Modification Available Performance Enhancement Service Note

N1092D DCA-M Sampling Oscilloscope

An improved extinction ratio calibration is available for DCA-M Sampling Oscilloscopes with option 30A

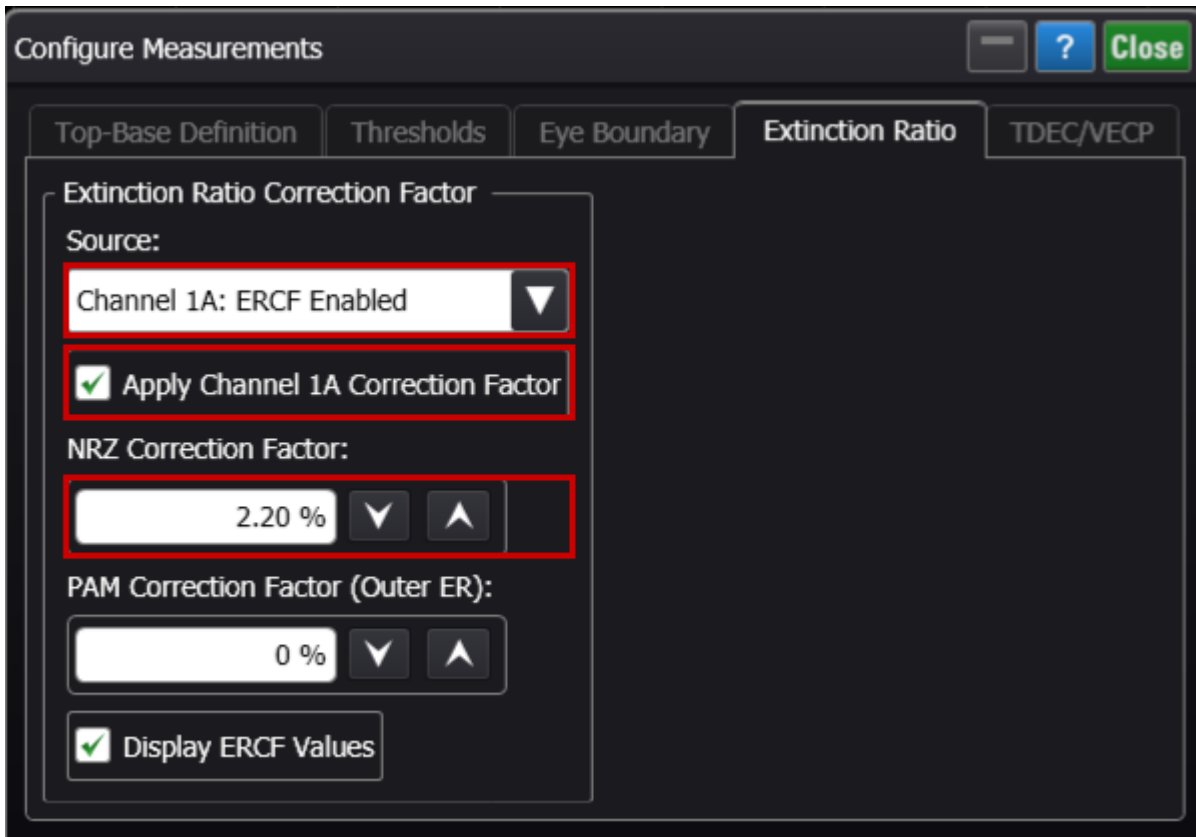
For N1092x DCA-M instruments with option 30A, units with the improved ER calibration are identified in the Help > About dialog with a “C1” annotation following the serial number.

- If the “C1” annotation is present, the unit has the improved ER calibration
- If the “C1” annotation is not present, the unit has the older ER calibration
